Rezoning Transportation Analysis

Petition Number: 2020-039

General Location Identifier: Tax ID 12709221

Date	Description
04-22-20	First Review
05-20-2020	Second Review

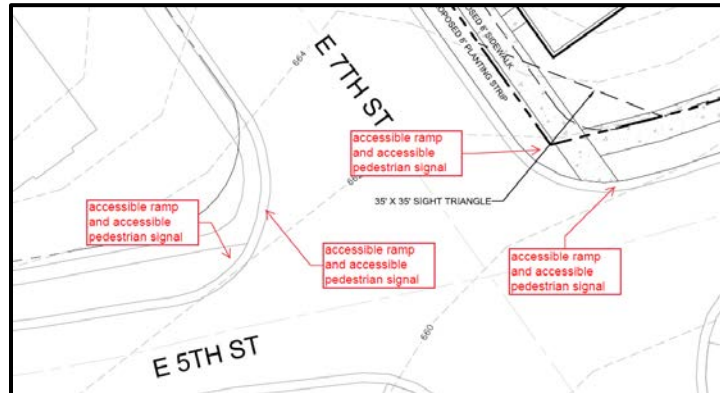
- The petitioner should revise the site plan and conditional note(s) to commit to construct dual ramps at the corner of E 7th Street and E. 5th Street to meet the City's Charlotte WAKS Policy and PROWAG. In addition, the developer should commit to provide accessible push buttons for its corner. The site plan should label and dimension both items from the back of curb and gutter and road centerline.

- We request for the petitioner should revise the site plan and conditional note(s) to commit to construct dual ramps at the corner of Monroe Road and E. 5th Street to meet City's Charlotte WAKS Policy and PROWAG. The site plan should label and dimension both items from the back of curb and gutter and road centerline.
